1101 WESTERN AVENUE
Seattle, WA

GGLO
AMLI Residential
Administrative Design Review Response
08.19.2020
SDCI Project #: 3029789-LU

RESPONSE TO ADR

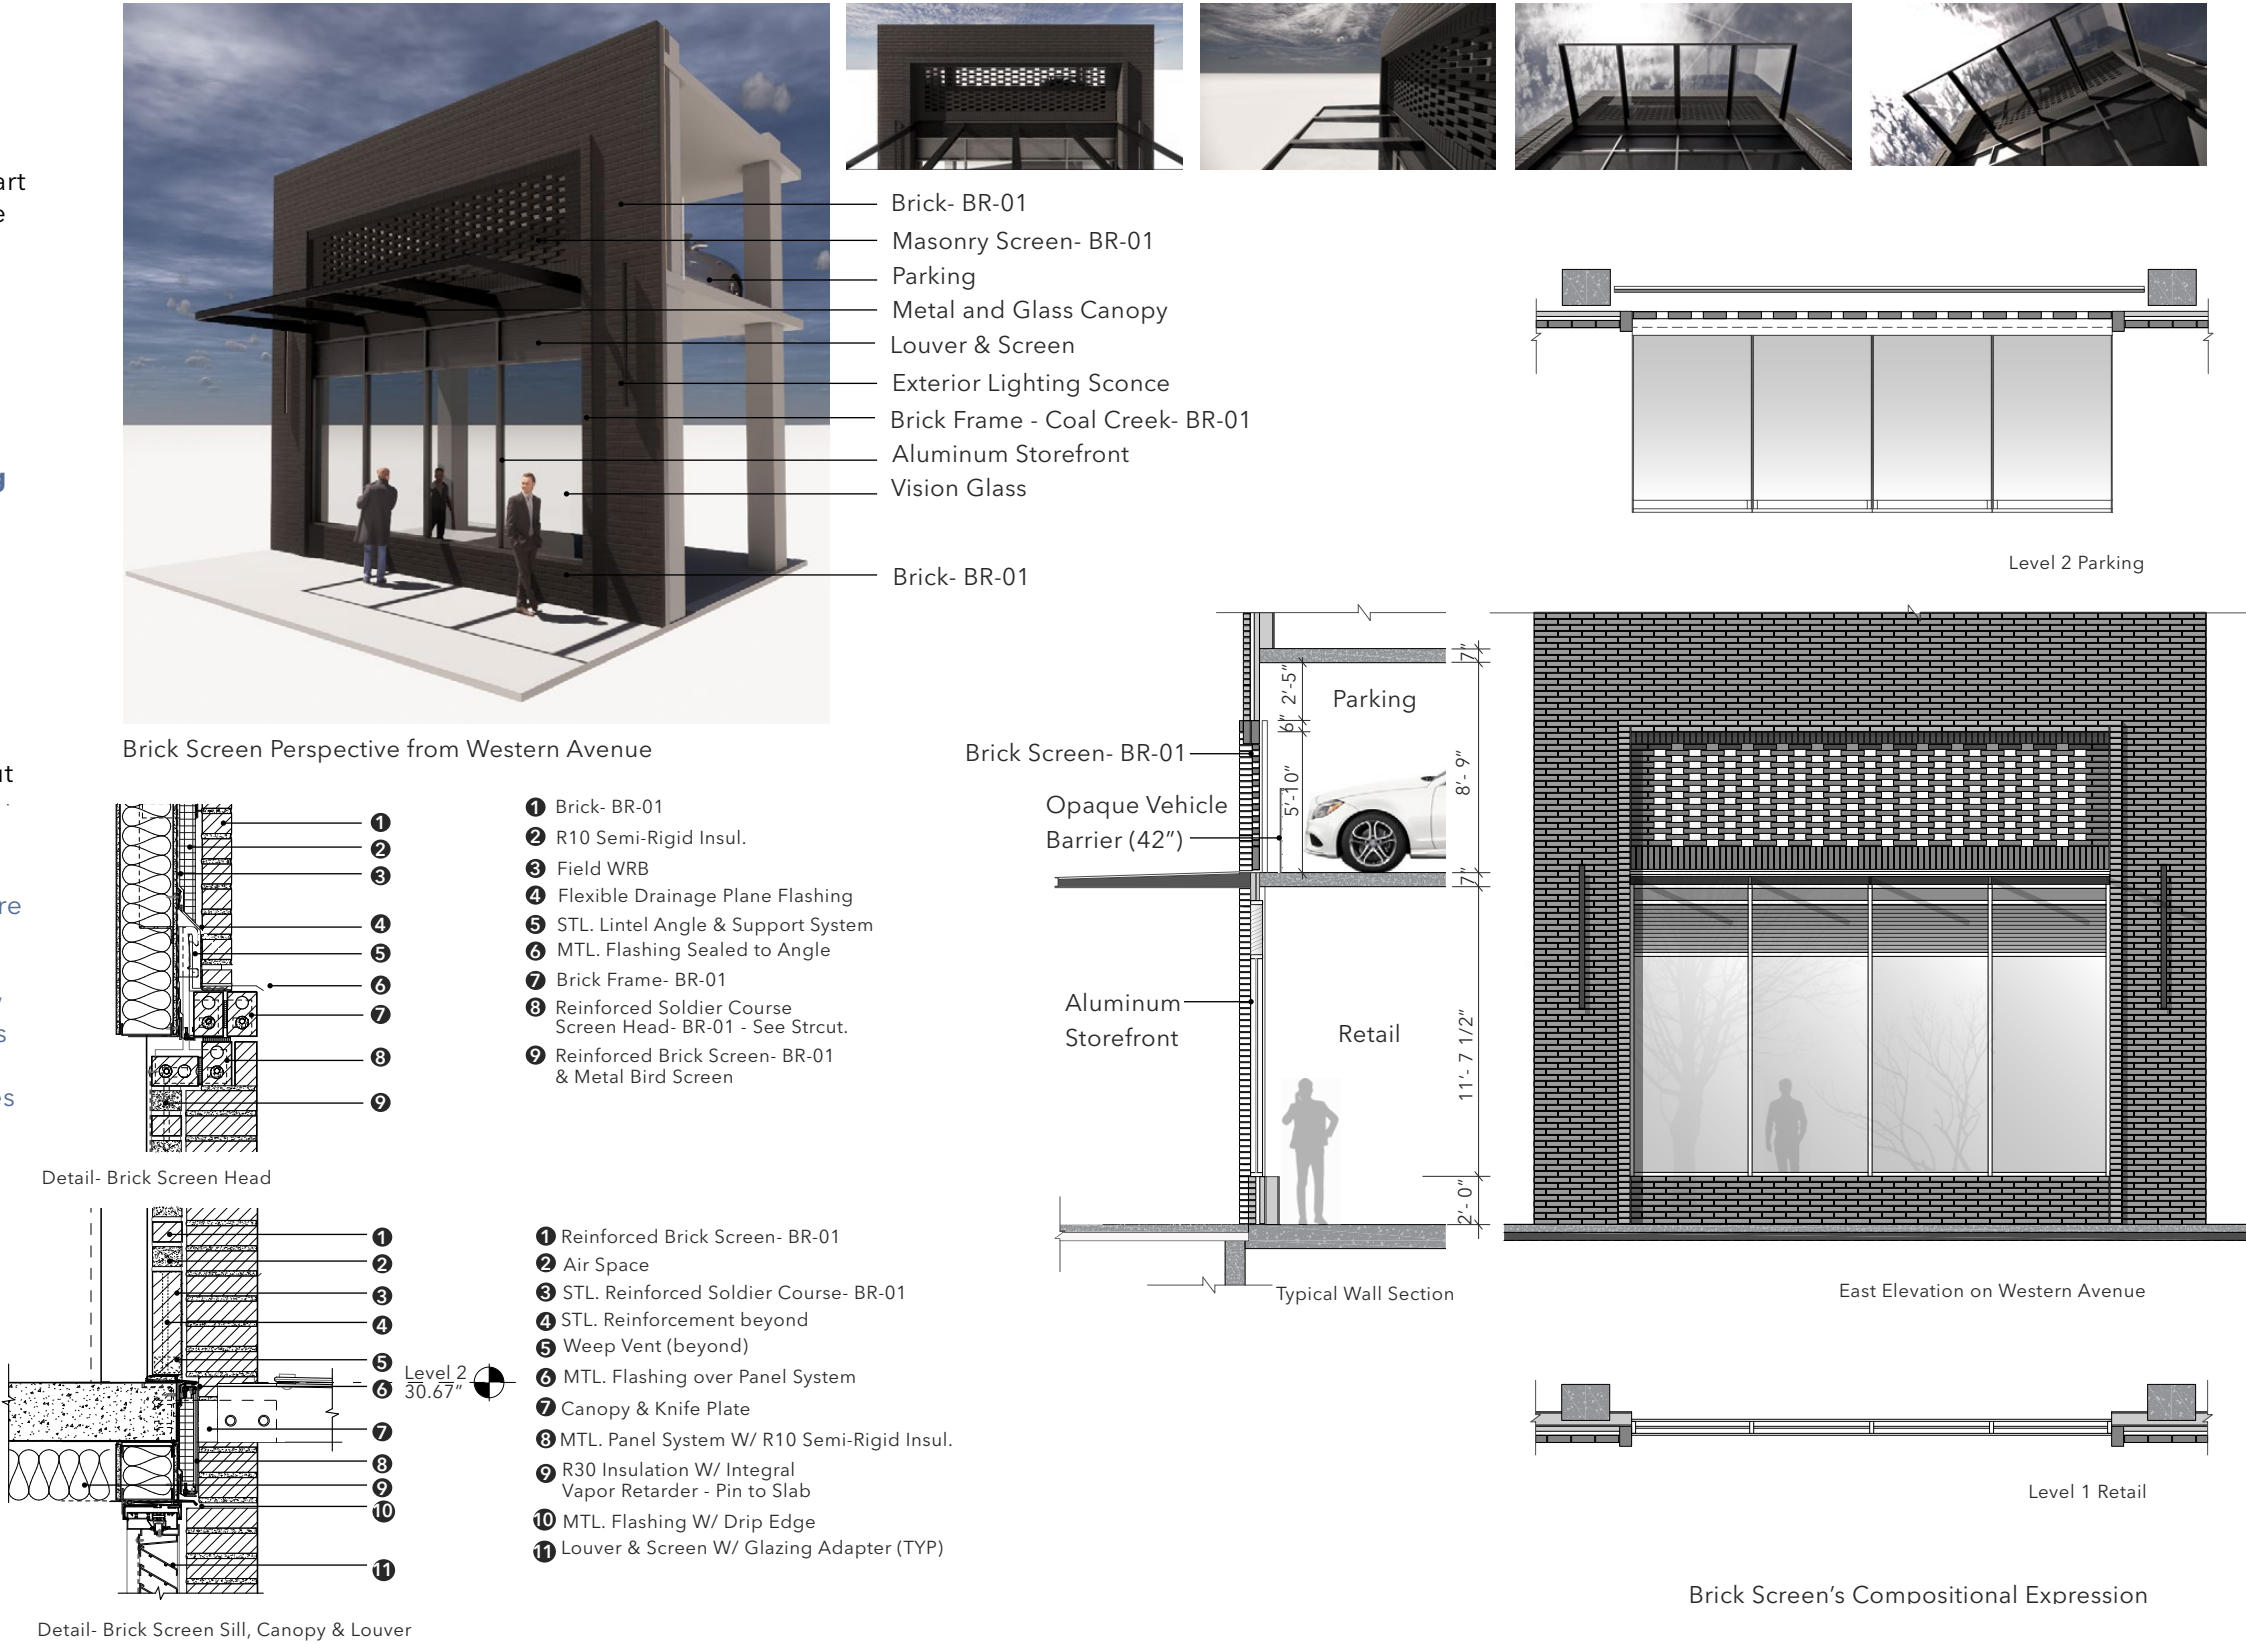
- a. Staff notes the Board’s previous concern regarding the expression of the above-grade parking level as part of the larger podium composition, but agrees that the revised design is well integrated compositionally and does not appear as a separate ‘other’ element. (B-4, E-2, B-3)
- b. For the next review, please provide details for the brick ‘screening’ element. (B-3,B-2)

Please see drawings on this page for full screening details.

GROUND FLOOR PLAN
CODE COMPLIANT CANOPIES

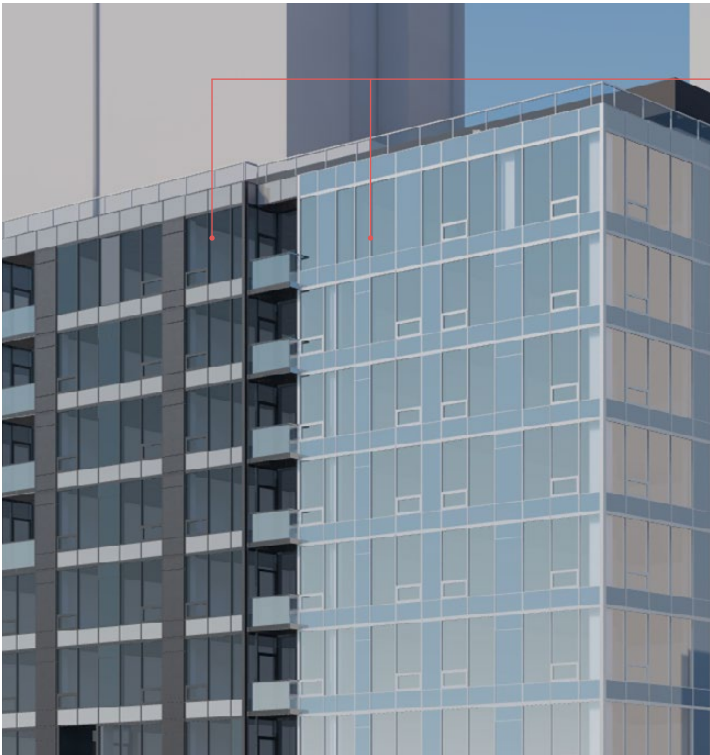
Continuous weather protection at 8' of depth conflicts with street tree placement per city arborist.

The project seeks a modification to the code required depth of 8’ of weather protection at Western Ave. to accommodate street tree placement per the city arborist. Please reference drawing on following page for recommended variation.

Level 17 Plan - ADR

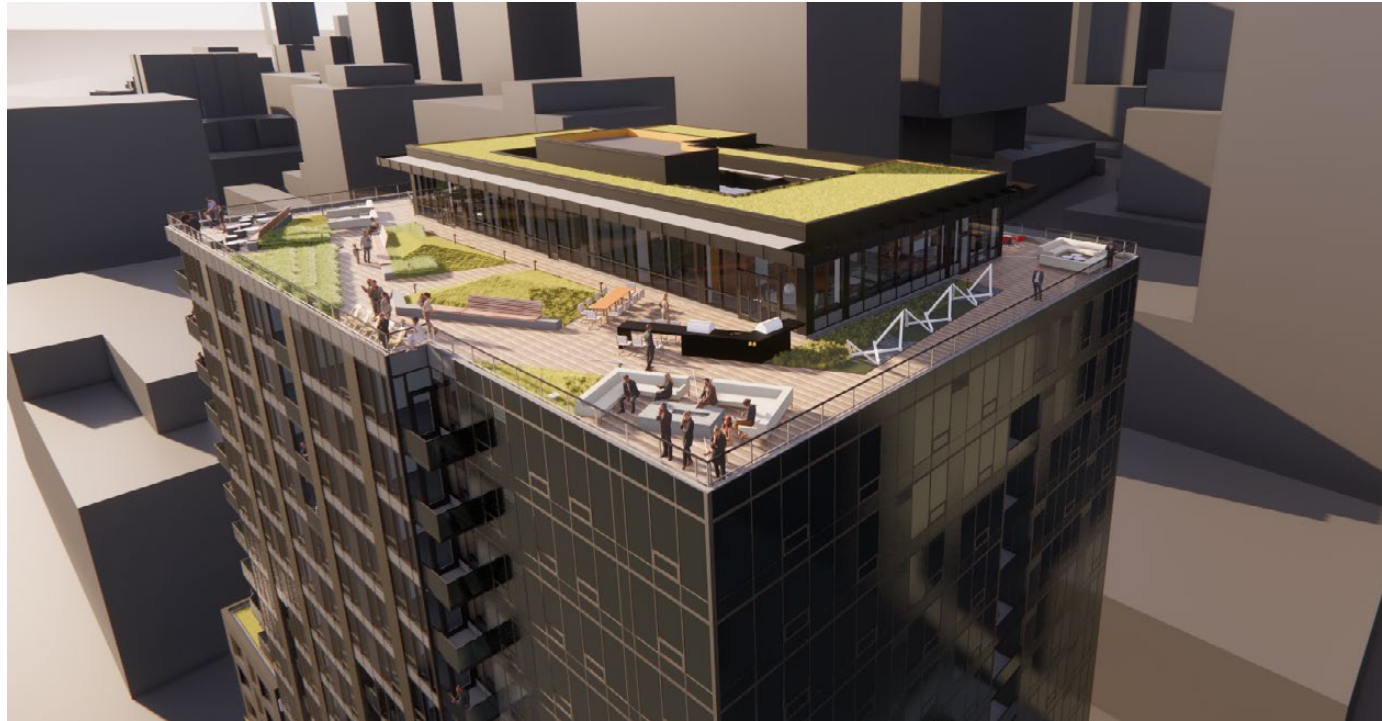
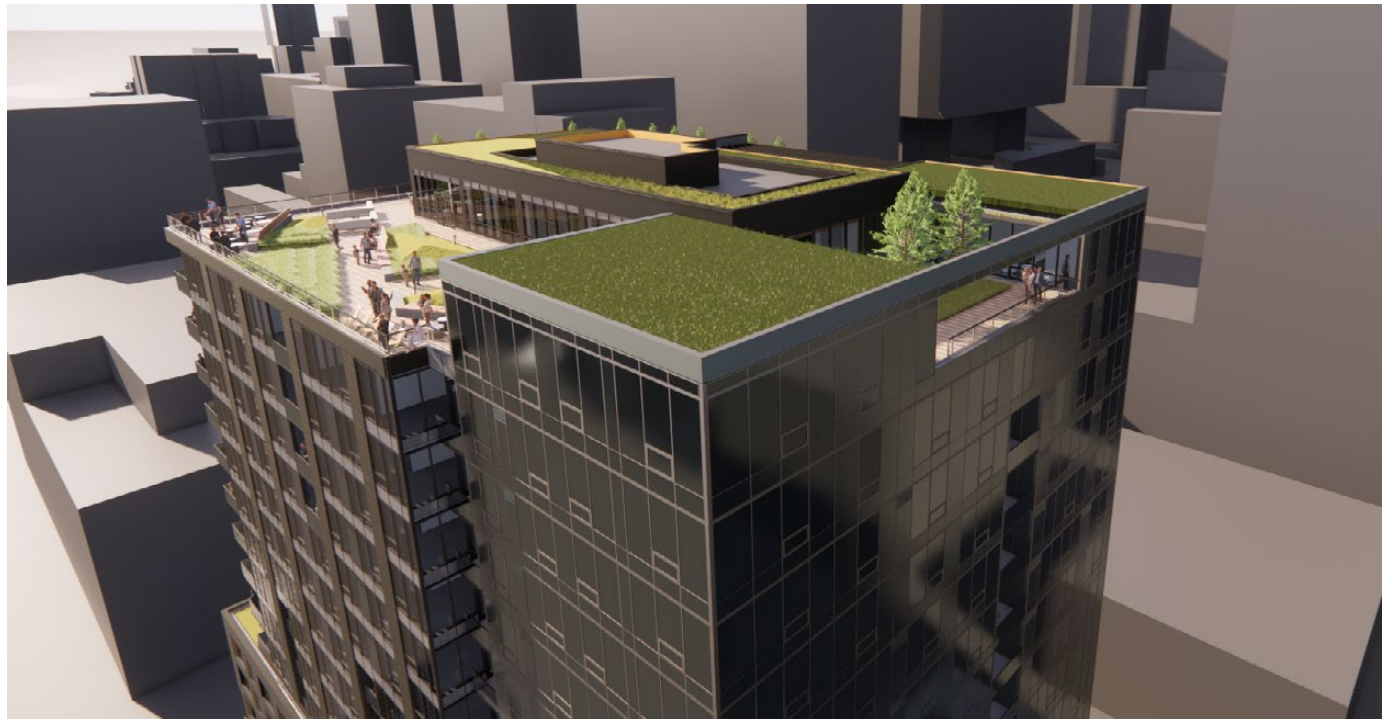
The project seeks to exceed the 35% allowable rooftop area by about 6% (1,050sf) to create more clearly distinct and articulated rooftop elements as to meet the intent of the Design Guidelines and as requested through Design Review.

The The Proposed departure supports **Design Guideline A-2 Enhance the skyline.** The updated design amplifies the expression of the south tower creating significant vertical distinction through height and singularity of materiality to promote visual interest and variety in the downtown skyline. The project proposes a new front door for the waterfront and creates a gesture appropriately scaled for encounter by land or water.
